Email:
Your Ref: 19/05560/OUT
Our Ref: ph_240320_19_05560_Ironbridge houses

19/05560/OUT Outline application (access for consideration comprising formation of two vehicular accesses off A4169 road) for the development of (up to) 1,000 dwellings; retirement village; employment land comprising classes B1(A), B1(C), B2 and B8; retail and other uses comprising classes A1, A2, A3, A4, A5, D1 and D2; allotments, sports pitches, a railway link, leisure uses, primary/nursery school, a park and ride facility, walking and cycling routes, and associated landscaping, drainage and infrastructure works. Ironbridge Power Station, Buildwas Road, Ironbridge, Telford, Shropshire, TF8 7BL

Planning Application Ref. 19/05560/OUT
Development at Former Ironbridge Power Station
Landscape and Visual Review
for the Shropshire Hills AONB Partnership
March 2020

View from the Wrekin summit with greenfield land shown in the masterplan for housing development shown approximately in dashed yellow line (photo courtesy of SHAONBP)

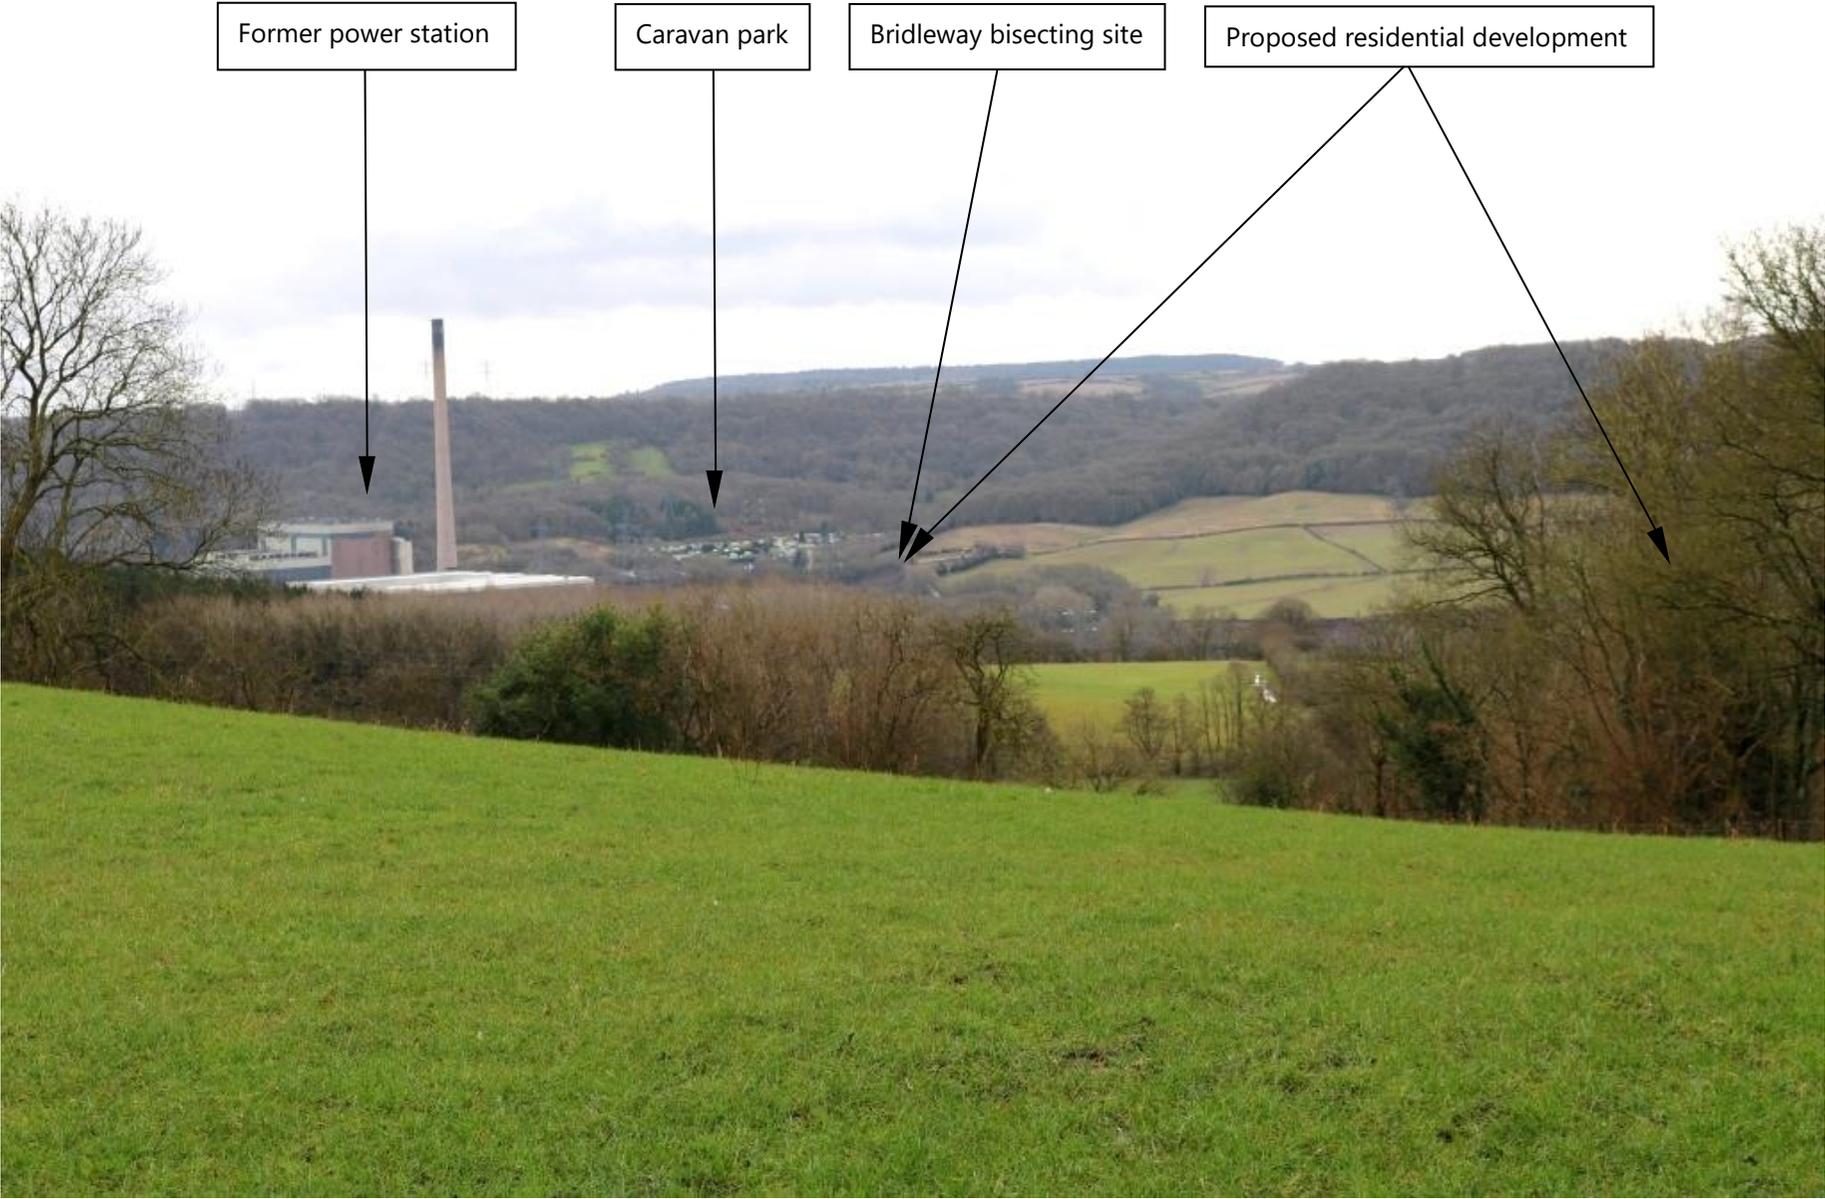
- 6.29 The above photograph (taken before the cooling towers were demolished) clearly illustrates the very sparsely-settled nature and high quality of the majority of the wider landscapes, both within and adjacent to the AONB. Very few of the existing settlement clusters are visible in the view: the

conurbations south of Telford - including Ironbridge - are well-screened even in winter by the network of dense blocks and belts of woodland.

View from B4380 looking south east (zoom lens, photo courtesy of SHAONBP)

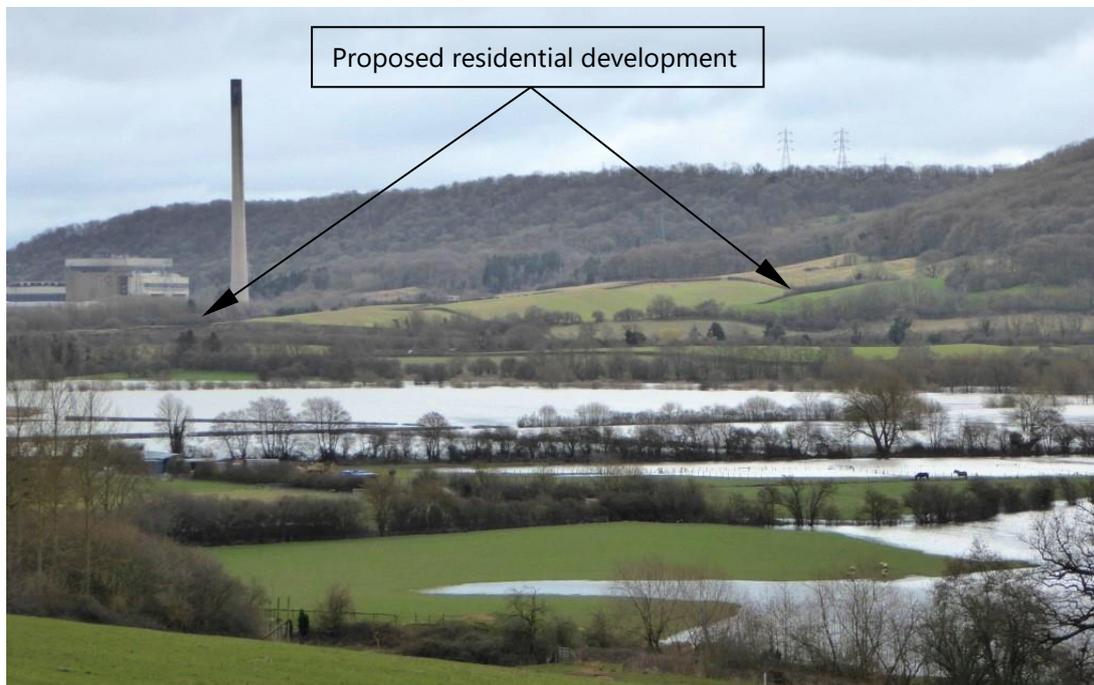
- 6.39 Another key view that was not identified or assessed in the LVIA is from a viewpoint along the B4380, c. 2.4km north west of the site.
- 6.40 As with the previous example, the difference in character and quality between brownfield and greenfield land, and the unsettled nature of the surrounding landscape context, are very clear from this point, as are the extent and likely degree of adverse landscape and visual effects.
